APPLICATION NO.	FILING DATE	FIRST NAMED INVENTOR	ATTORNEY DOCKET NO.	CONFIRMATION NO.
10/720,821	11/24/2003	Douglas B. Wilson	114089.120	5355
23483	7590	01/13/2006	EXAMINER	
WILMER CUTLER PICKERING HALE AND DORR LLP 60 STATE STREET BOSTON, MA 02109			LUONG, VINH	
			ART UNIT	PAPER NUMBER
			3682	
DATE MAILED: 01/13/2006

Office Action Summary	Application No.	Applicant(s)
	10/720,821	WILSON, DOUGLAS B.
	Examiner Vinh T. Luong	Art Unit 3682

ATTACHMENT 1

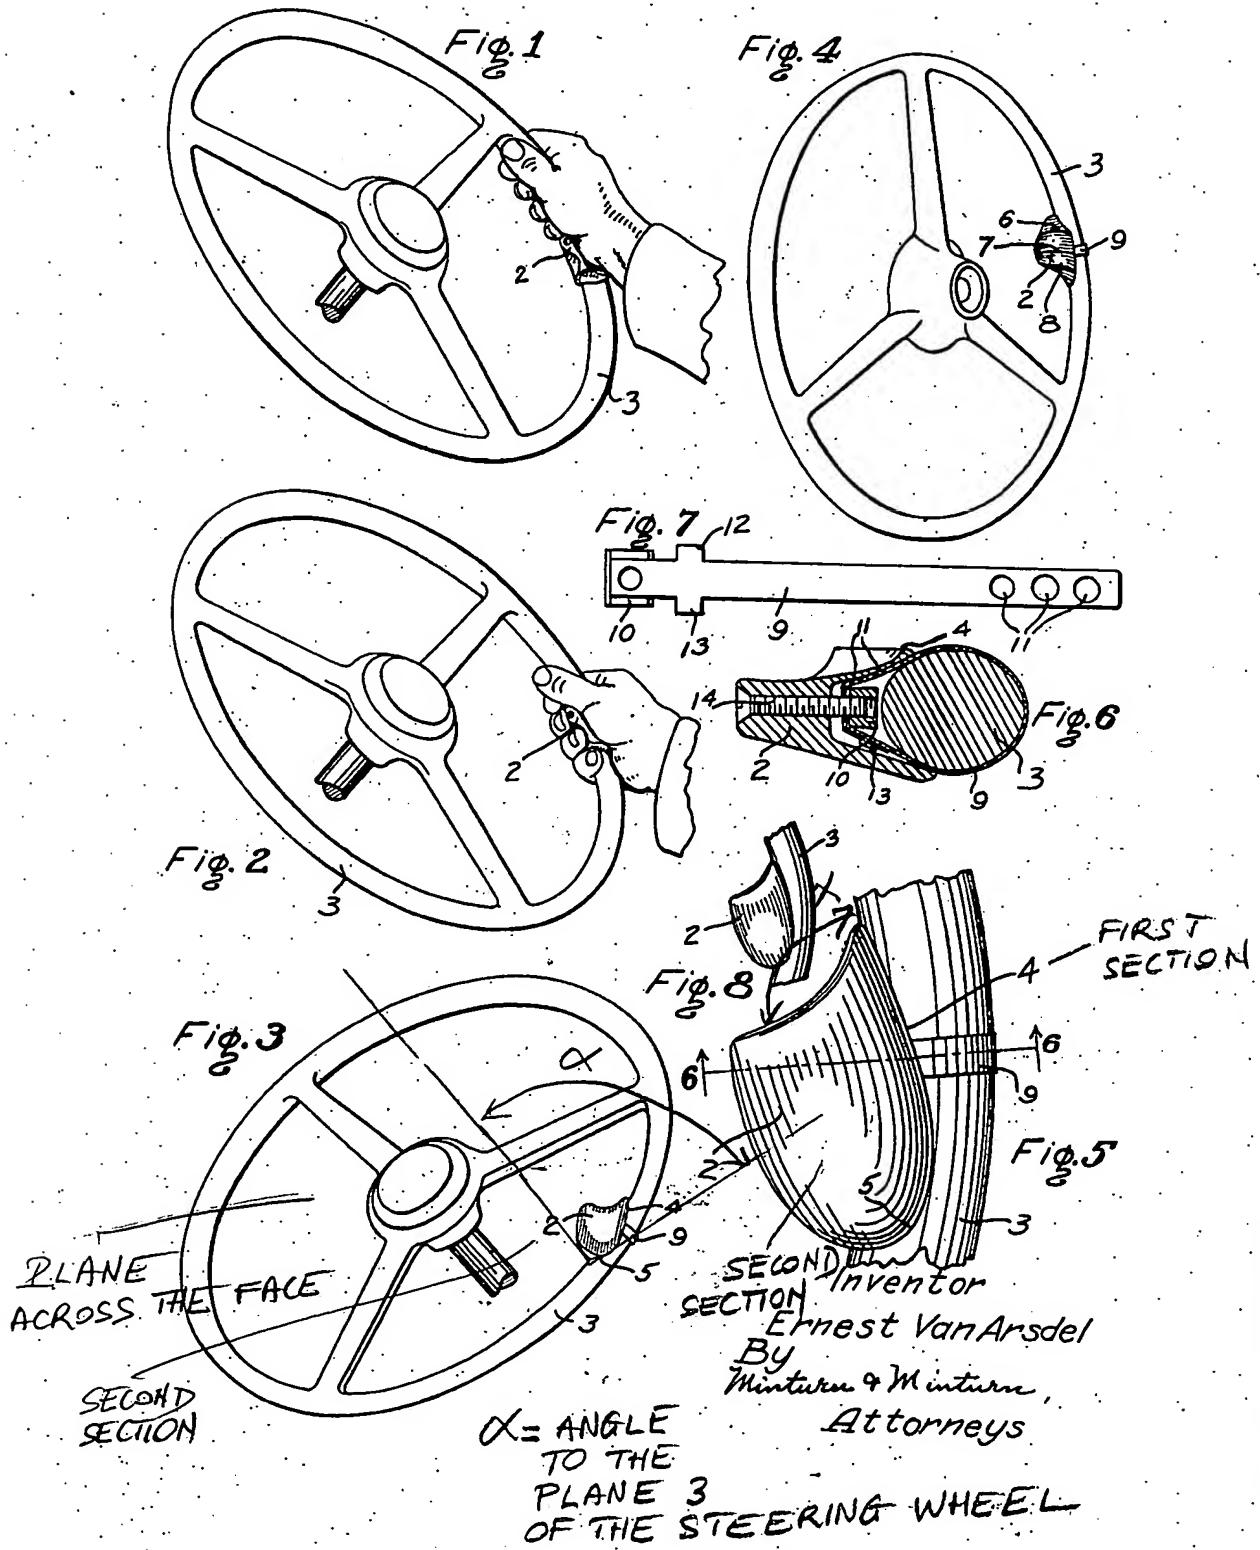
Regarding claim 20, Van Arsdel teaches a fatigue relieving/preventing apparatus associated with a steering wheel 3 for controlling a vehicle comprising:

a first section 4 (i.e., horizontal section in Fig. 3) that connects to a peripheral portion 3 of the steering wheel 3; and

a second section 2 (i.e., upward section in Figs. 3 and 5) that connects to and extends from the first section 4 at the peripheral portion 3 of the steering wheel 3, the second section 2 extends from the first section 4 outward at an angle (see angle α in Figs. 3 and 5 of the Attachment 1) to a plane (Att. 1) across a face to the steering wheel 3, with the second section 2 inherently for supporting at least a portion of a vehicular operator's body (e.g., the hand as seen

in Figs. 1 and 2) when pressure from the portion of the vehicular operator's body on the second section 2 is less than the pressure for deforming the second section 2 out of interference with the vehicular operator's ability to operate the steering wheel 3, and deforming out of interference with the vehicular operator's ability to operate the steering wheel when pressure from the portion of the vehicular operator's body on the second section is equal to or greater than the pressure for deforming the second section out of interference with the vehicular operator's ability to operate the steering wheel 3. *Ibid.*, right column on page 1, lines 29-54.

ATTACHMENT 2

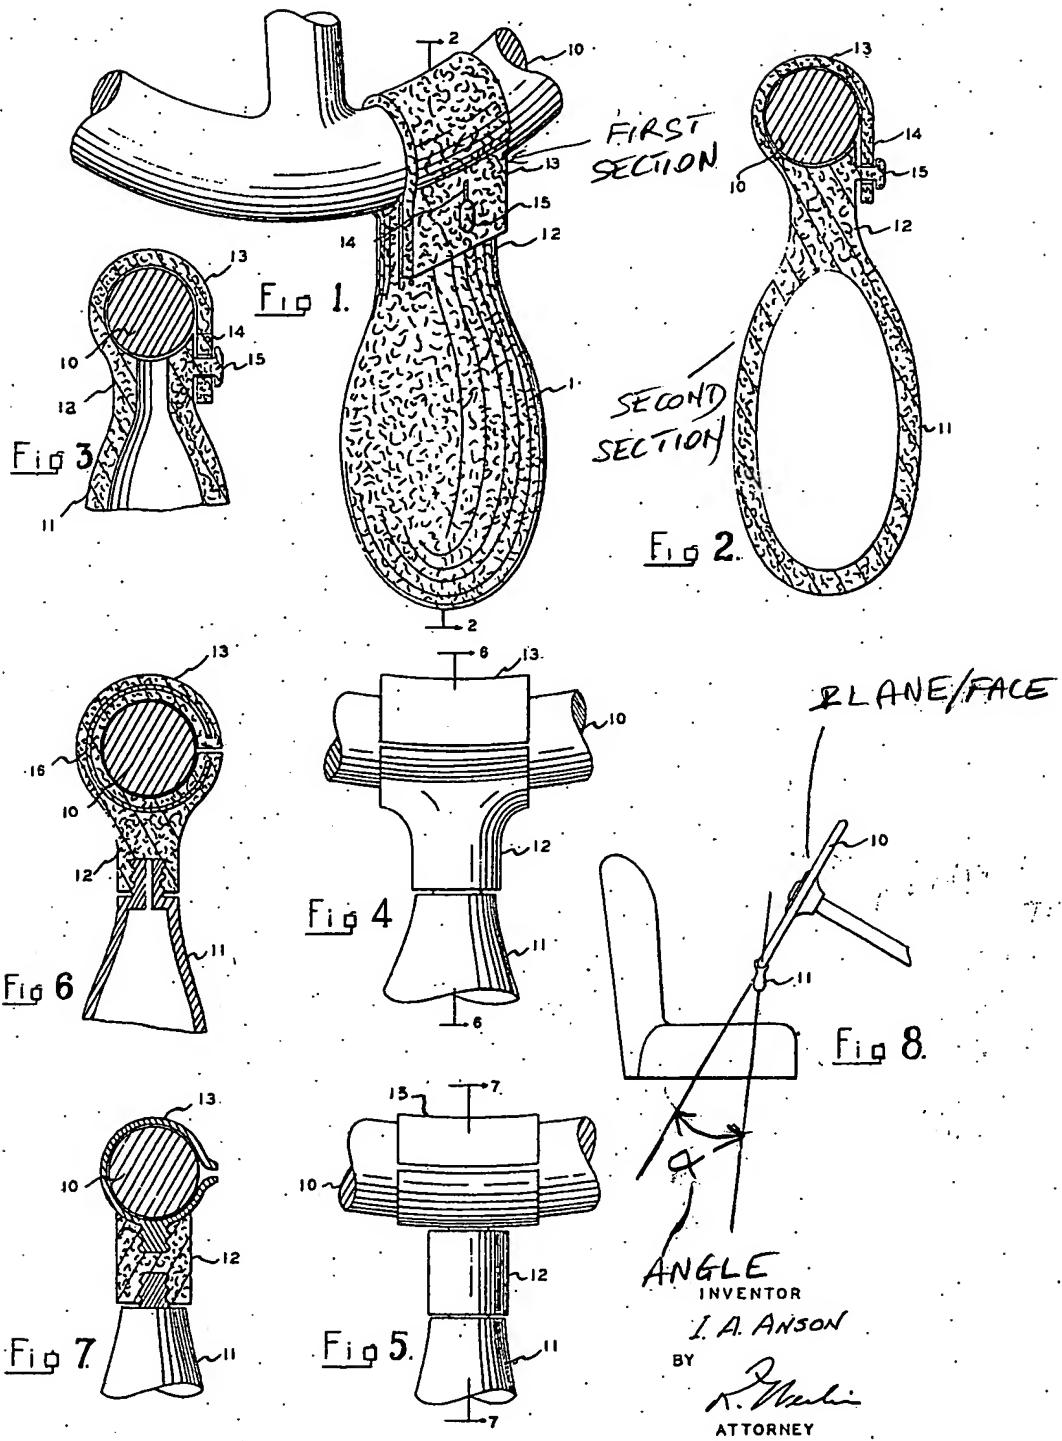
Regarding claim 20, Anson teaches a fatigue relieving/preventing apparatus associated with a steering wheel 10 for controlling a vehicle comprising:

a first section 13 that connects to a peripheral portion of the steering wheel 10;
style="padding-left: 40px;">a second section 11 extends from the first section at the peripheral portion of the steering wheel 10, the second section 11 extends from the first section 13 outward at an angle (see angle α in Fig. 8 of Attachment 2) to a plane (Att. 2) across a face (Att. 2) to the steering wheel 3, the second section 11 inherently for supporting at least a portion of a vehicular operator's body (e.g., the hand) when pressure from the portion of the vehicular operator's body on the second section 11 is less than the pressure for deforming the second section 11 out of interference with the vehicular operator's ability to operate the steering wheel 10, and deforming out of interference with the vehicular operator's ability to operate the steering wheel 10 when pressure from the portion of the vehicular operator's body on the second section 11 is equal to or greater than the pressure for deforming the second section 11 out of interference with the vehicular operator's ability to operate the steering wheel 10.

ATTACHMENT 3

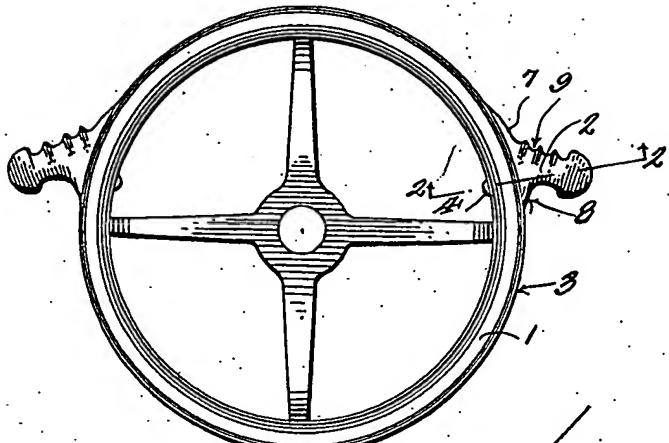
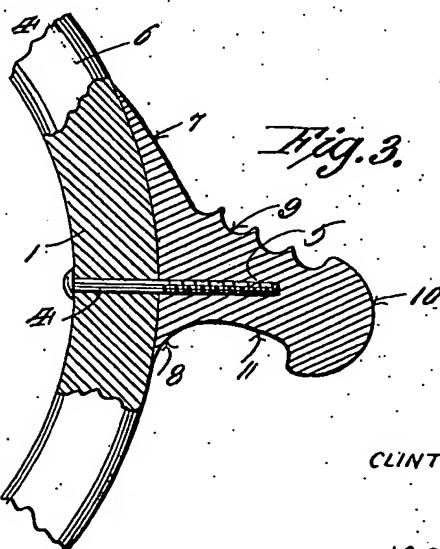
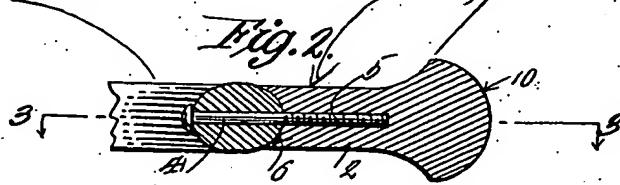
Regarding claim 20, Laubach teaches a fatigue relieving/preventing apparatus associated with a steering wheel 1 for controlling a vehicle comprising:

a first section 7, 8 that connects to a peripheral portion of the steering wheel 1;
a second section 10 that connects to, and extends from, the first section 7, 8 at the peripheral portion of the steering wheel 1, the second section 10 extends from the first section 7, 8 outward at an angle (see angle α in Fig. 2 of the Attachment 3) to a plane (Att. 3) across a face

(Att. 3) to the steering wheel 1, the second section 10 inherently for supporting at least a portion of a vehicular operator's body (e.g., the hand) when pressure from the portion of the vehicular operator's body on the second section 10 is less than the pressure for deforming the second section 10 out of interference with the vehicular operator's ability to operate the steering wheel 1, and deforming out of interference with the vehicular operator's ability to operate the steering wheel 1 when pressure from the portion of the vehicular operator's body on the second section 10 is equal to or greater than the pressure for deforming the second section 10 out of interference with the vehicular operator's ability to operate the steering wheel 1.

Regarding claim 27, the second section 10 includes at least two second sections 10 that each connect to the first section 7, 8 at separate locations (by comparing Applicant's Fig. 2 with Laubach's Fig. 1).
